### APPEAL SUMMARY

<b>Appeal ID:</b> 14734	<b>Project Address:</b> 2245 NE 36th Ave
<b>Hearing Date:</b> 3/8/17	<b>Appellant Name:</b> Alyssa Leeviraphan
<b>Case No.:</b> B-004	<b>Appellant Phone:</b> 503-224-4032
<b>Appeal Type:</b> Building	<b>Plans Examiner/Inspector:</b> John Cooley
<b>Project Type:</b> commercial	<b>Stories:</b> 3 <b>Occupancy:</b> E <b>Construction Type:</b> IA, II-B, III-B
<b>Building/Business Name:</b>	<b>Fire Sprinklers:</b> Yes - throughout
<b>Appeal Involves:</b> Alteration of an existing structure, Addition to an existing structure	<b>LUR or Permit Application No.:</b>
<b>Plan Submitted Option:</b> pdf [File 1]	<b>Proposed use:</b> Educational - high school

**Building Code Appeal attachment**  
**Grant High School Modernization**

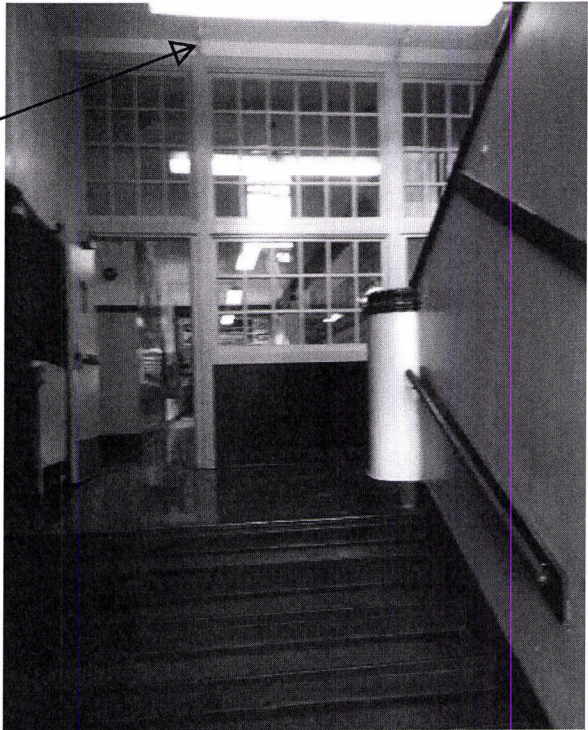
**Proposed Design** The proposed design preserves the existing kalamein frame relites and 90 minute rated doors at the corridor side of two exit stair enclosures. A new fire sprinkler system will be installed throughout the entire building and will include new quick response heads above the relites to wet both sides of the glass. This condition is the subject of a previous appeal which is shown below.

2 FIRE SPRINKLER  
HEADS AT BOTH  
SIDES OF GLASS

WIRED GLASS SET  
IN KALAMEIN  
FRAMES

90 MIN. RATED  
DOORS WITH  
ELECTROMAGNETIC  
HOLD OPENS

**3. Water curtain at existing non rated glazing at stair enclosure in lieu of rated Fire Barrier: Granted as proposed.**

### GUARD AND HANDRAIL CONFIGURATION PROPOSED TO REMAIN AT EXISTING STAIRS

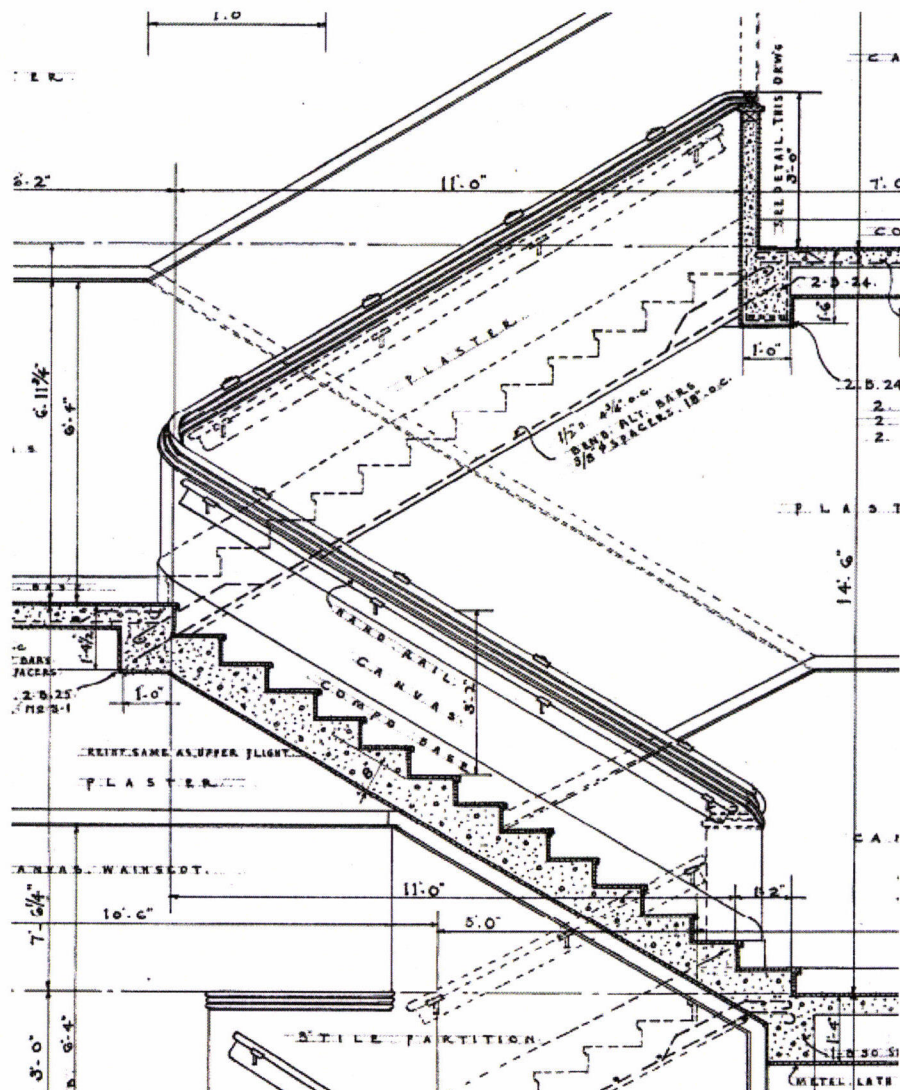
The proposed design would maintain the existing condition of guards and handrails at two exit stairs and five exit access stairs. The existing guards measure a minimum of 36 inches in height at stairs and landings. Existing 2" diameter wood handrails are placed 31" above stair nosings on both sides of stairs and typically lack the extensions and returns required by current code.

**4. Existing stair handrail mounting height of 31", without handrail extensions: Granted as proposed.**

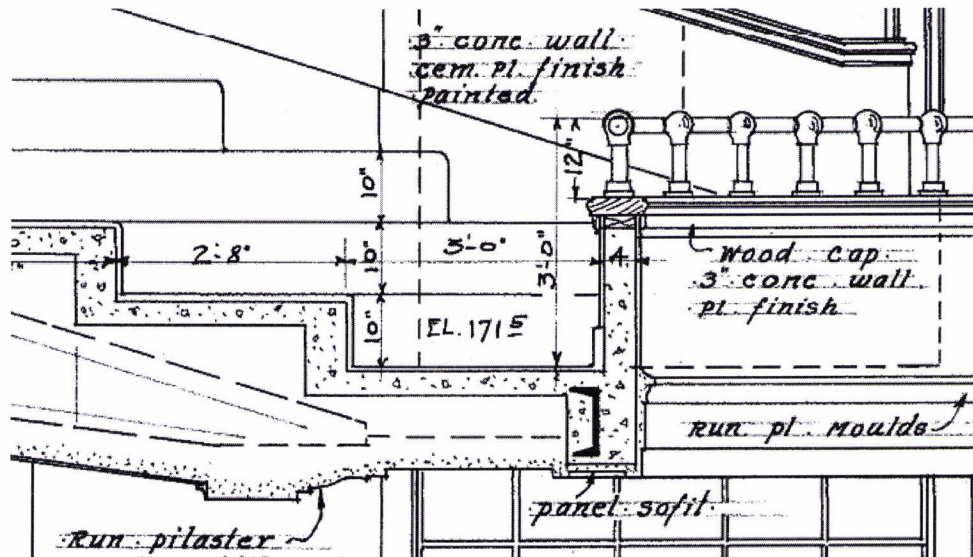
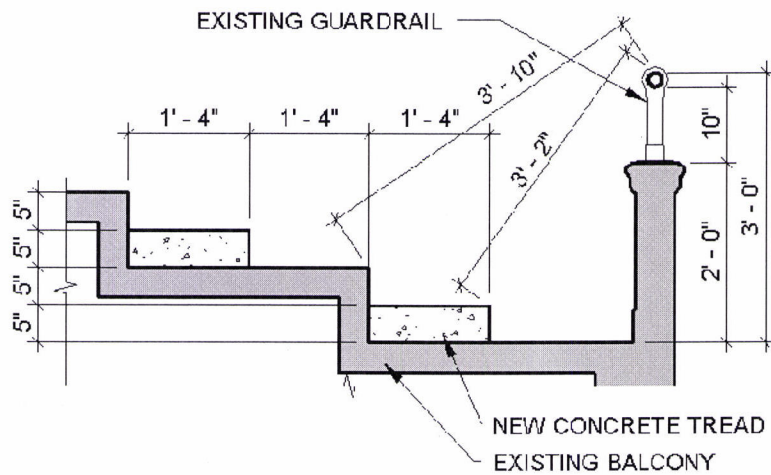
The existing guard at the front edge of the auditorium balcony built in 1927 is solid to a height of 24 inches above the floor and has a cap rail 36 inches above the floor. The gap between the cap rail and the top of solid portion of the guard is approximately 10". No change to the existing guard is proposed.

The existing aisles in the balcony are stepped with 10" risers. The proposed design includes the addition of new intermediate treads which are half the height and depth of the existing treads. This will be compliant with 1028.11.1 and 1028.11.2 but creates a non-compliance with 1028.14.3. The diagonal measurement between the nosing of the new bottom tread and the top of the guard will be 3'-2".

Existing condition:

Proposed design:

**5. Guardrail configuration at auditorium: Denied. Proposal does not provide equivalent protection.**

## GRANT HS NORTH WING EXISTING PLANS

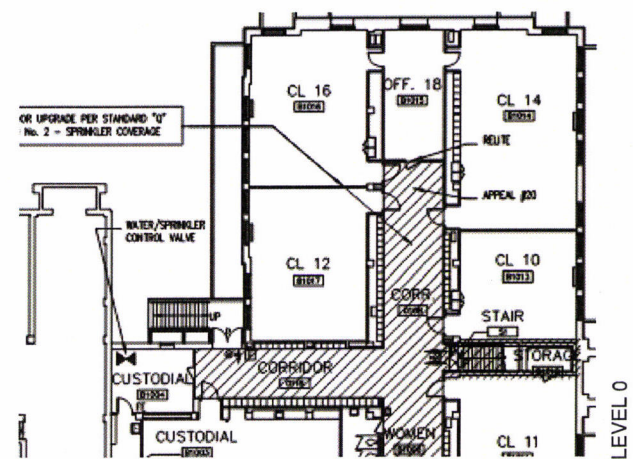
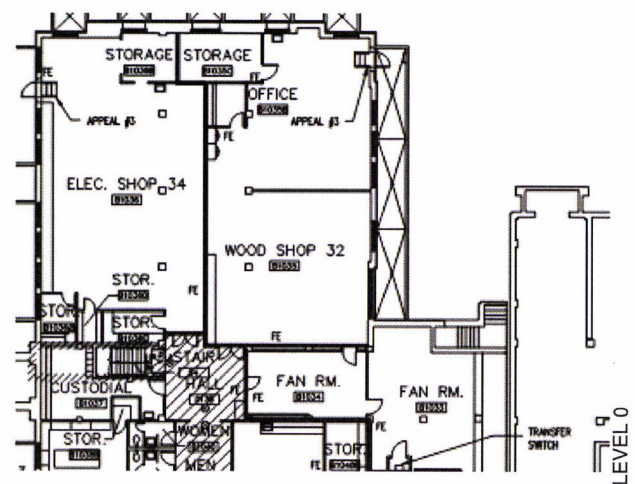
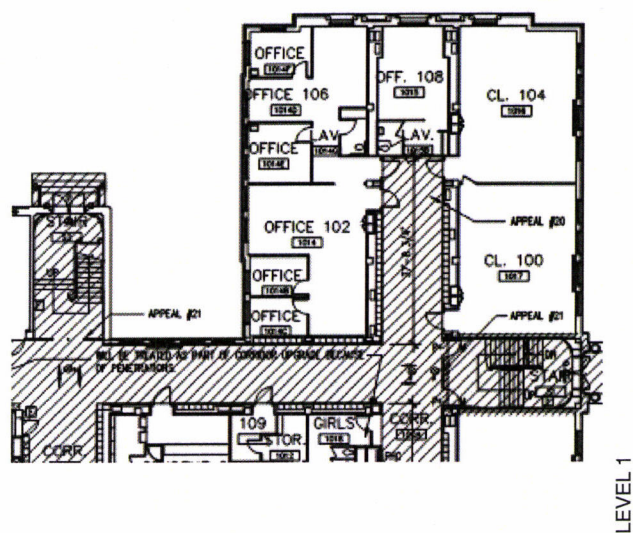
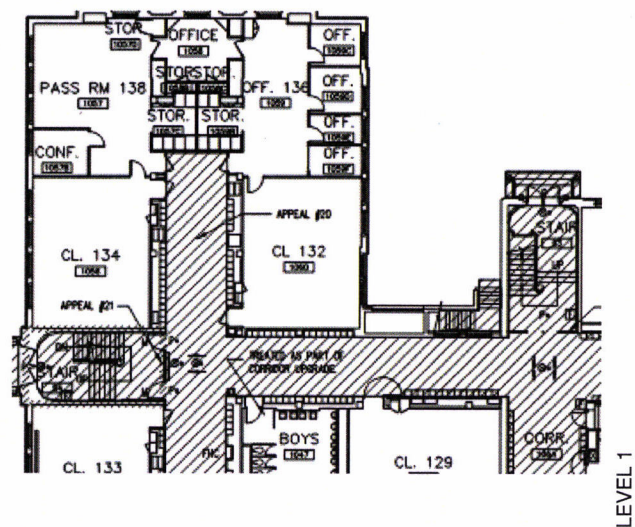
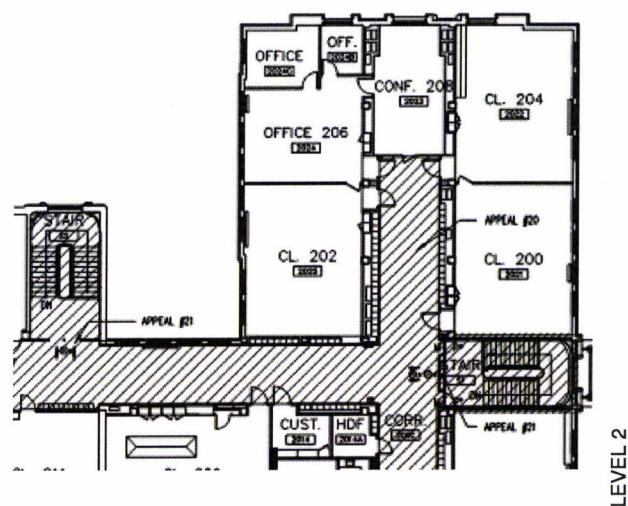
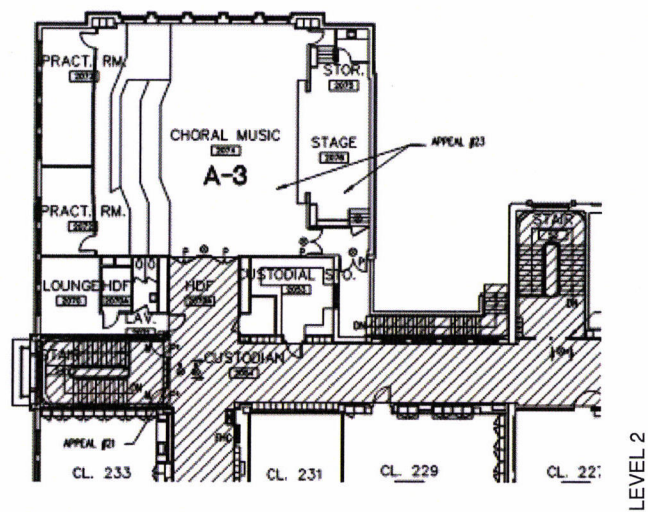
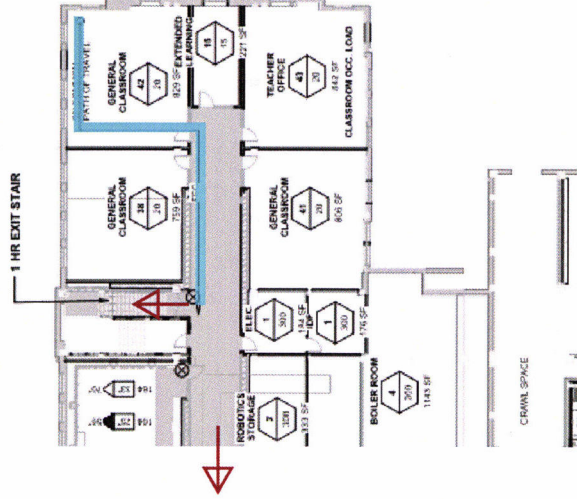
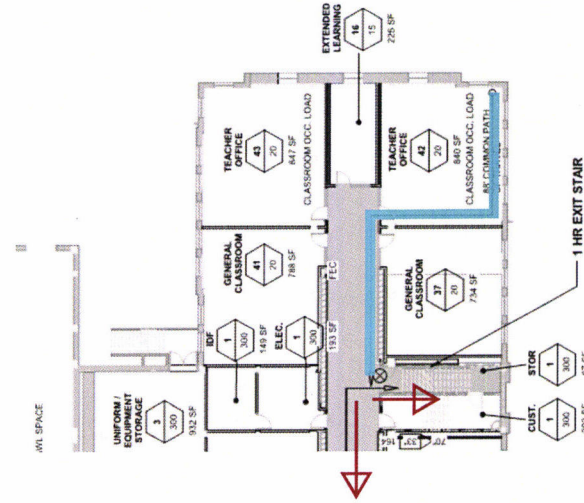
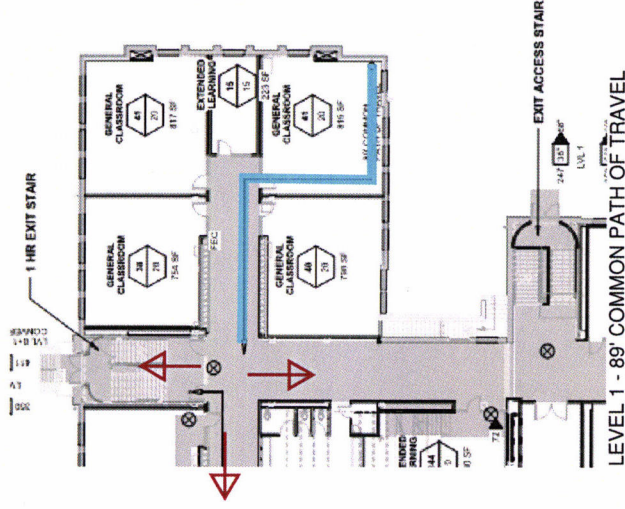
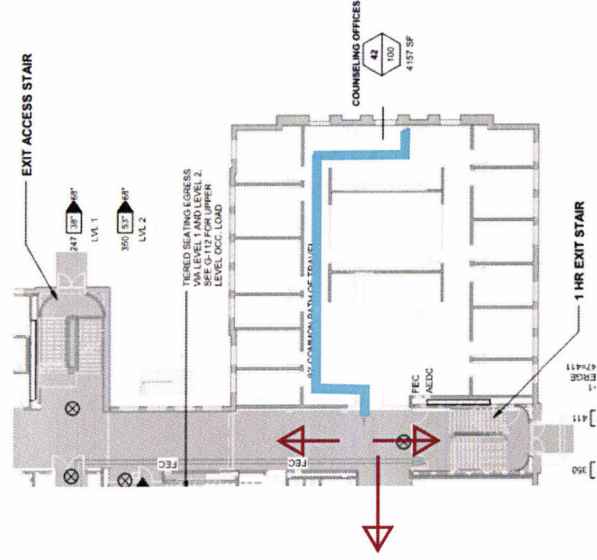
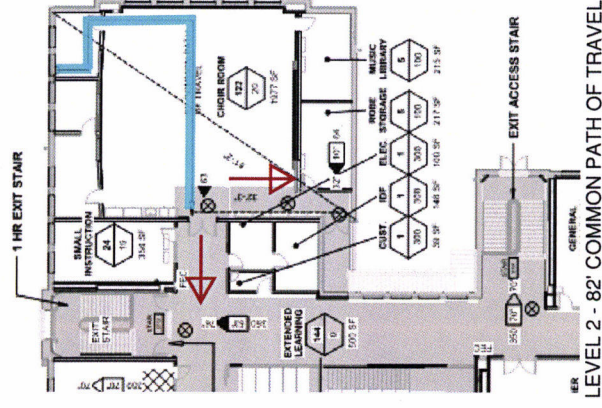
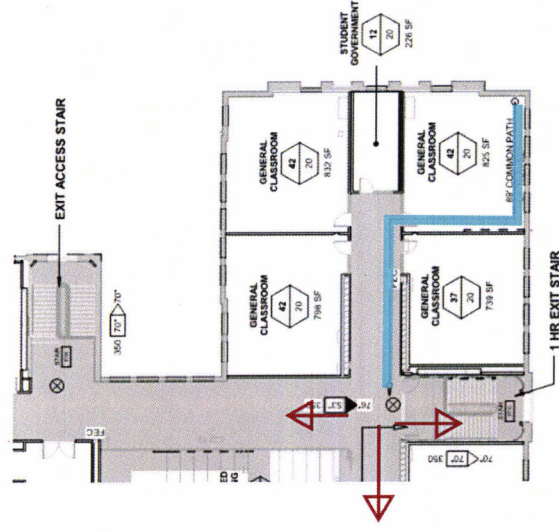
**Proposed Design** 1014.3 Common path of egress travel  
The common path of egress travel shall not exceed the common path of egress travel distances in Table 1014.3 (maximum 75 feet for group E occupancy).

LEVEL 0 - 89' COMMON PATH OF TRAVEL  
GRANT HS NORTH WING PROPOSED PLANS

LEVEL 0 - 89' COMMON PATH OF TRAVEL

LEVEL 1 - 89' COMMON PATH OF TRAVEL

LEVEL 1 - 92' COMMON PATH OF TRAVEL

LEVEL 2 - 82' COMMON PATH OF TRAVEL

LEVEL 2 - 89' COMMON PATH OF TRAVEL

**6. Increase in common path of egress travel up to 92' maximum in reconfigured areas: Granted as proposed.**
